Interview Summary

Application No.
09/808,686

For: PRECISION ELECTRIC MITER BOX

AMENDMENT

Fig 1

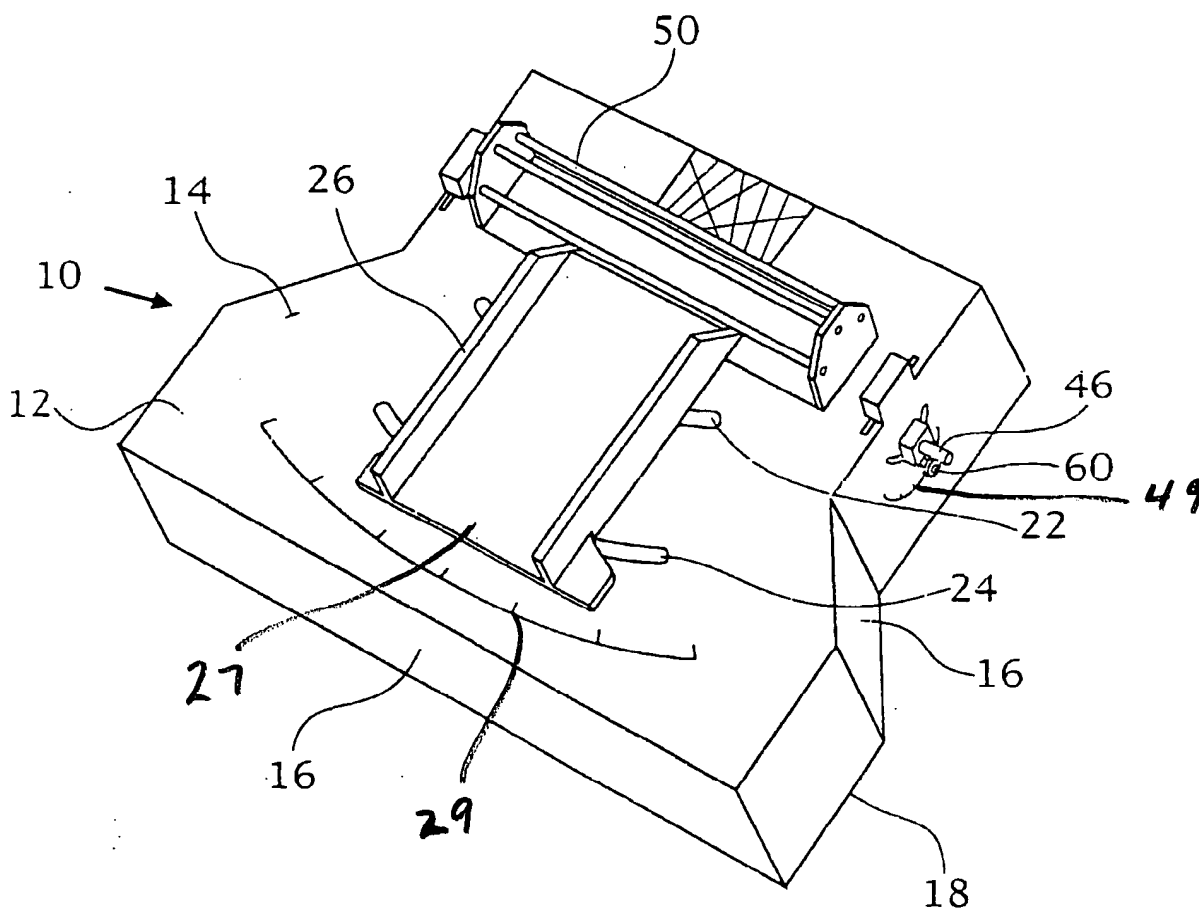
The drawings were objected to because of several informalities. The drawings have been corrected as shown in the red markings to add numerals or to correct numerals as suggested by the Examiner. A duplicate copy of the red marked FIGS. 1, 3, 4, 10, 11, 16, 21 and 22 are enclosed to a Letter To The Official Draftsman. Also enclosed are formal drawings incorporating the corrections. Also, two sheets of drawings were submitted which included FIGS. 20-22. Please cancel the sheet of drawings which show FIGS. 20-22 and retain the sheet of drawings showing FIGS. 20-24.

Fig 3

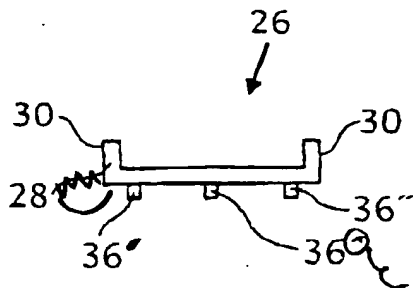
Mr. Gamson faxed a proposed amendment prior to the interview, and Mr. Watson presented a model of the invention. The proposed amendment was discussed. Mr. Gamson stated that Figures 3-9 were still not accurate and proposed additional changes in the interview. Mr. Dexter stated that these additional changes will be further considered upon receipt of the formal amendment.

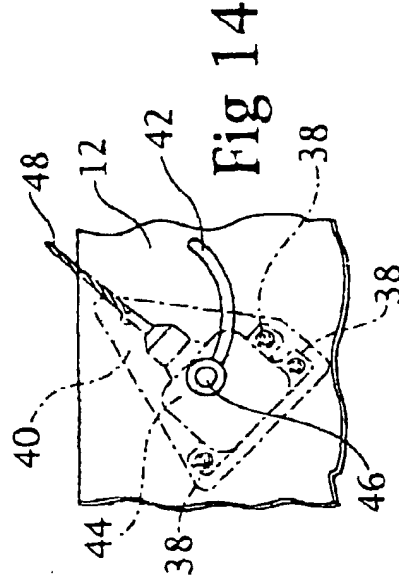
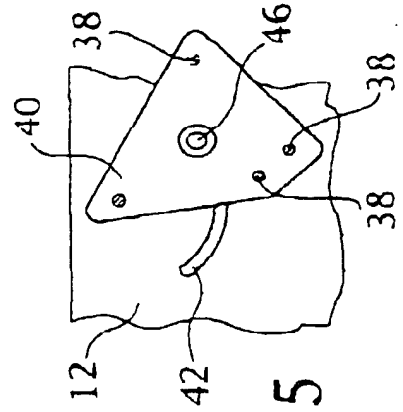
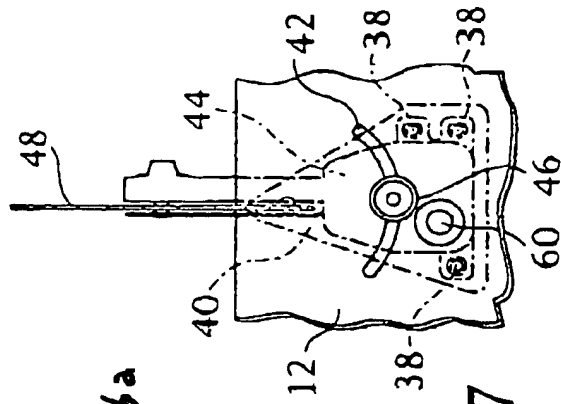
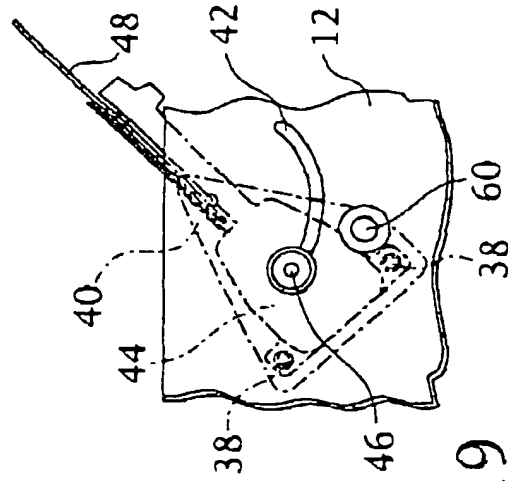
As shown in FIGS. 14, 15, 17 and 19 the plates 40 swivel as the motor, the support means, and the cutting means are moved to the selected angle (see page 9, lines 8-14 and page 11, lines 12-13). The swivel is "a coupling device that allows free turning of the parts attached to it" (Webster's New

-- The swivel design of the cutting means 38, the motor 44 and the motor support means 38 with the plates 40 provides a -- .
